**REVISED RESPONSE TO REQUEST FOR ADDITIONAL INFORMATION****APR1400 Design Certification****Korea Electric Power Corporation / Korea Hydro & Nuclear Power Co., LTD****Docket No. 52-046****RAI No.: 167-8191****SRP Section: 09.01.01 - Criticality Safety of Fresh and Spent Fuel Storage and Handling****Application Section:****Date of RAI Issue: 08/20/2015****Question No. 09.01.01-2**RAI 9.1.1-4: Criticality prevention under normal and accident conditions of fuel handling**REQUIREMENTS AND GUIDANCE**

**RAI No.:** 167-8191

**SRP Section:** 09.01.01 - Criticality Safety of Fresh and Spent Fuel Storage and Handling

**Question No. 09.01.01-4**RAI 9.1.1-10: Modeled thickness of neutron absorber plates**REQUIREMENTS AND GUIDANCE**

Figure 3.7.16-1 (page 1 of 1)  
Discharge Burnup vs. Initial Enrichment for Region II Racks

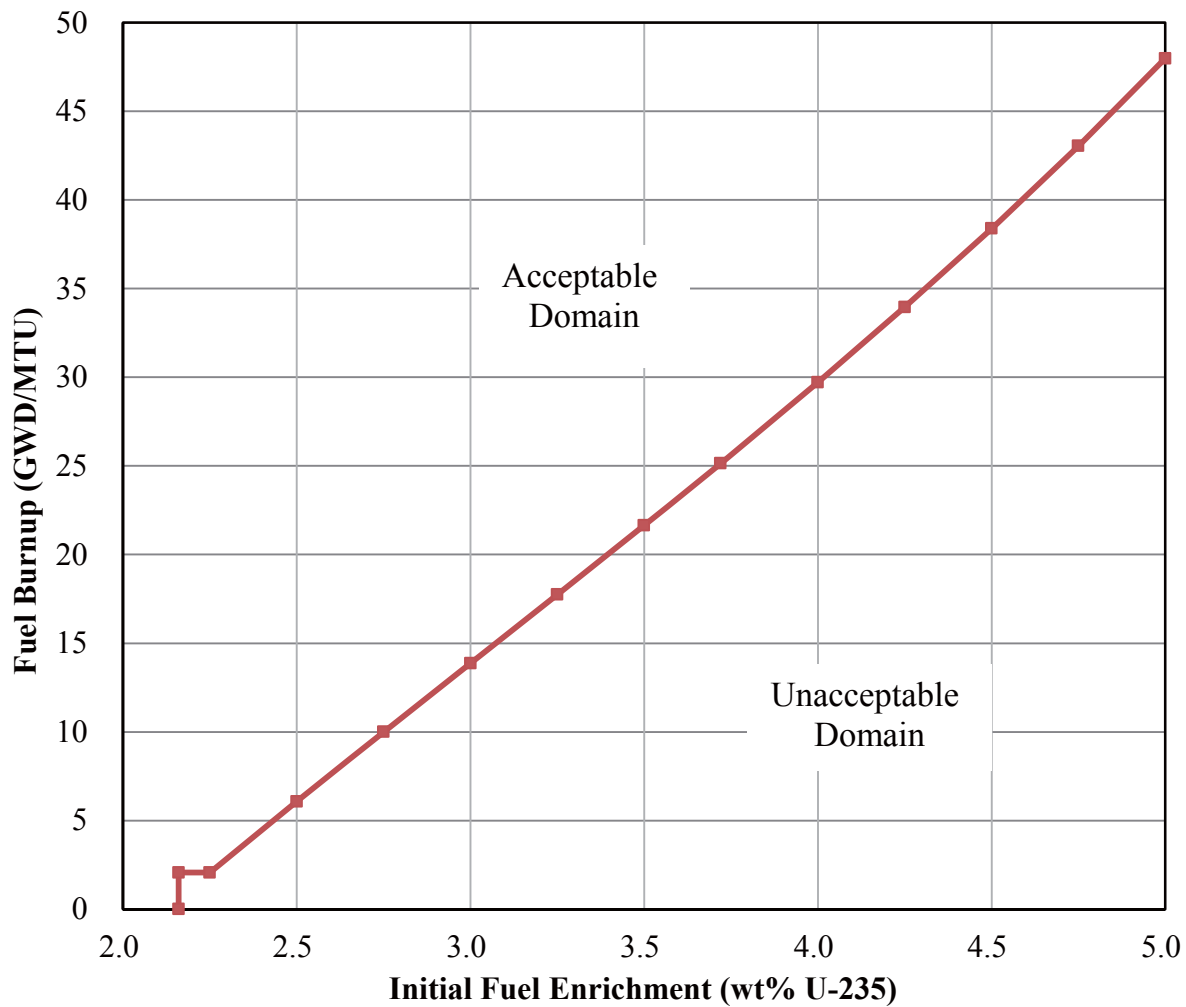
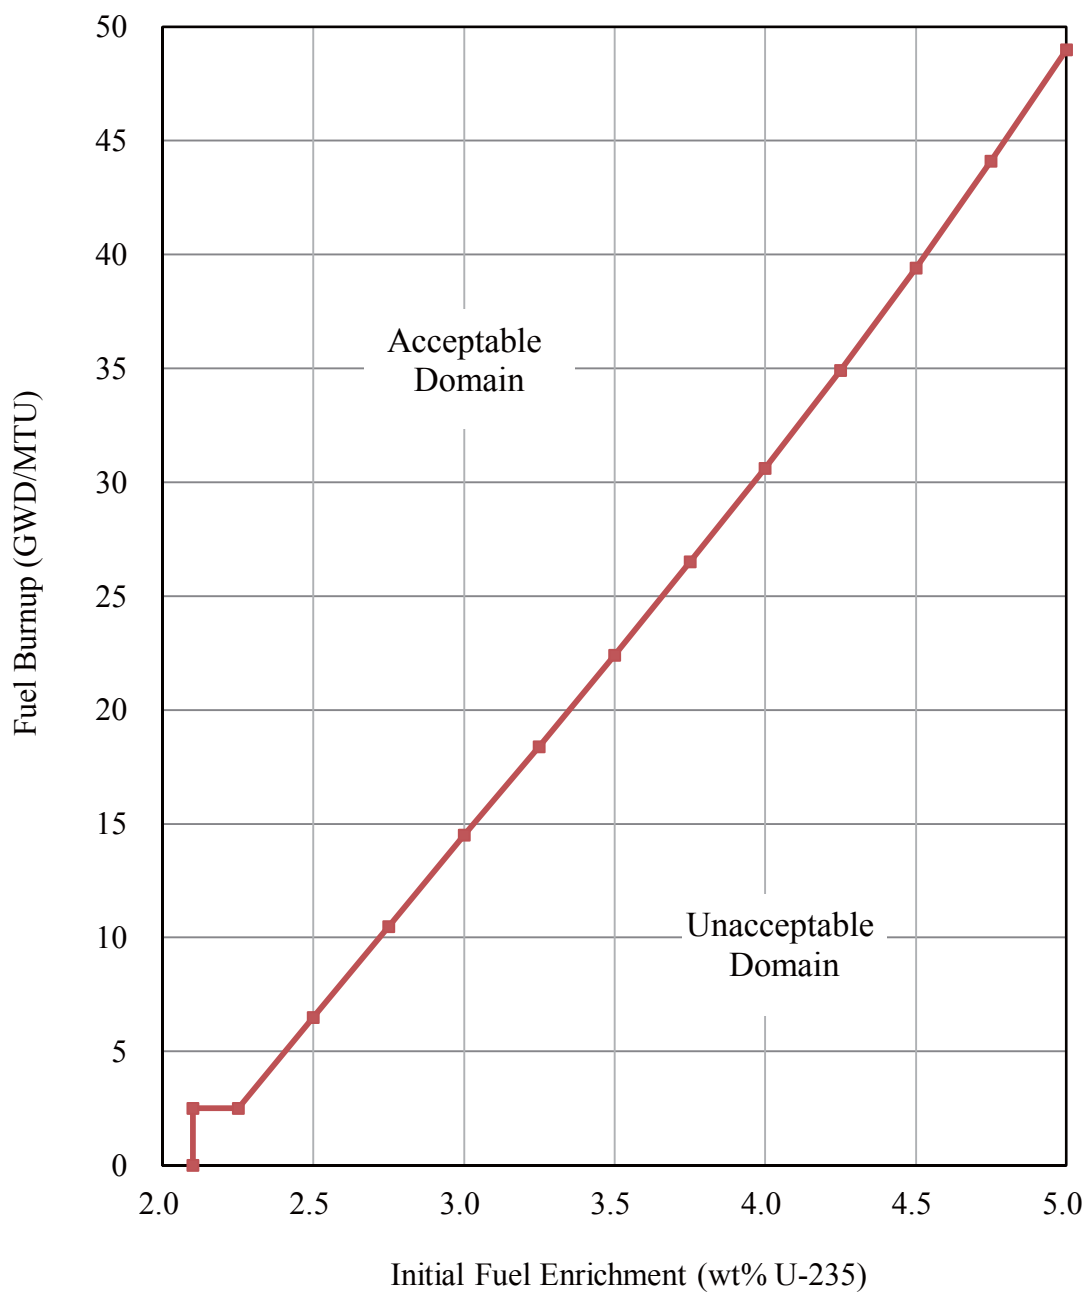
Figure 3.7.16-1 of technical specifications will be revised as indicated in Attachment 2.

This figure should be replaced with the figure in the next page.
